# Environmental Review Team Report Nursery Acres Waterford, Connecticut

## ENVIRONMENTAL REVIEW TEAM REPORT ON NURSERY ACRES WATERFORD, CONNECTICUT

The Eastern Connecticut Environmental Review Team was asked to prepare an environmental assessment for a proposed subdivision of land in the Town of Waterford. The project site is approximately 69+ acres in size and is located south and west of the intersection of Braman and Dimmock Roads. The property is presently owned by St. Joseph's Church in New London. Preliminary plans for the subdivision have been prepared by William Kent.

### Drainage Areas

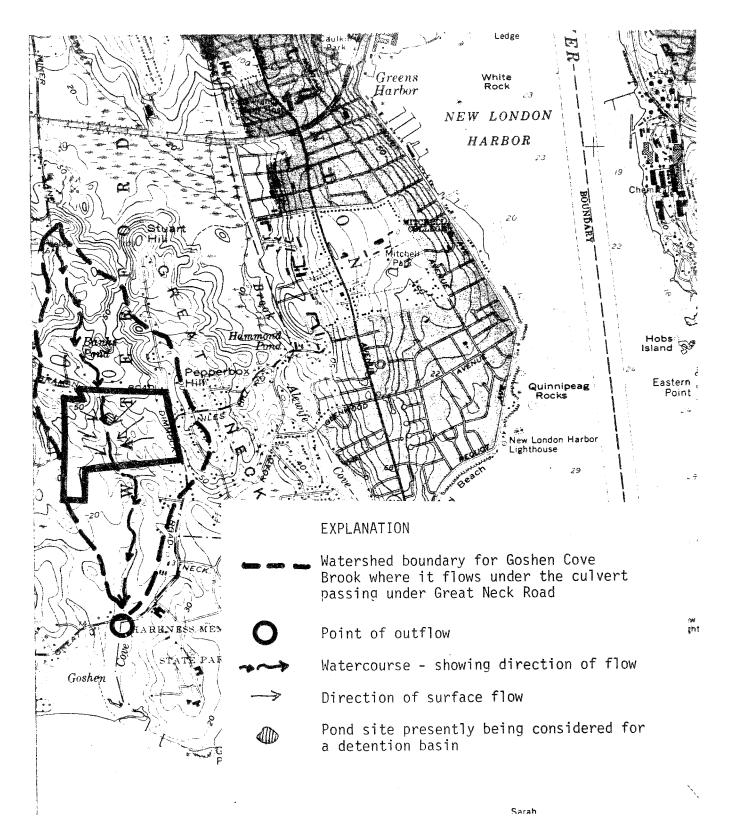
Development of the property under the present proposal will increase the percentage of runoff from the site for a given rainfall amount. This difference would result from the construction of impermeable surfaces, such as

The results of the Team geologist's calculations, shown below for the design point chosen, should be considered as "ball park" figures with regard to the estimated peak flows and runoff volumes. The calculated <u>percentages</u> of increase, however, should be fairly close.

Although the increases shown in the tables above are 10 percent or less, it is recommended that careful consideration of stormwater management be given. It is suggested that the applicant be required to submit detailed hydrological information prior to approval of the proposed subdivision.

This information should include pre- and post-development runoff estimates from the site for the 10, 25, 50 and 100 year storm events. Because the Town would like to see off-site flows following the development maintained at present levels, a possible method for controlling runoff on the site might be to establish a detention basin or basins which would alleviate peak flows. Detailed design specifications for all stormwater detention basins should be submitted and reviewed by appropriate town officials. In addition, all storm drain outlets should include a designed energy dissipator to help protect areas below the outlet from gullying.

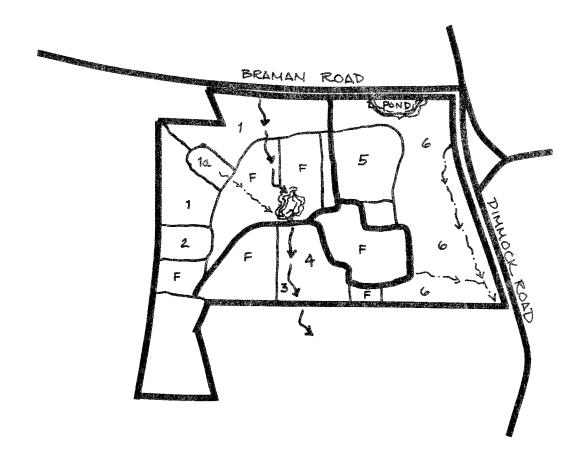
The impact of intensive development will be to remove another piece of forest land from the production of wood products. The impact of the forest on development of houselots would be best broken down by area: Area #1 will provide lots with minimum ground disturbance (root destruction), most of the trees will survive to provide natural landscaping. Area #2 is rather poorly drained with tree roots near the surface; killing trees by filling or by wind blowdown is a real possibility. Areas #3 and 4 are designated as open-space as it should be, as this is wetland. Area #5 is covered with shrubs and short-lived trees, most of which are not suitable for house-lot landscaping; therefore, it is expected most of this will be removed and landscape planting be implemented. Area #6 will be the most impacted as the high water table combined with tall trees is going to create some blow-down and breakage. Also, the climbing vines are going to be unattractive. Clearing the vines with a bulldozer is going to cause even further damage; much breakage should be expected.
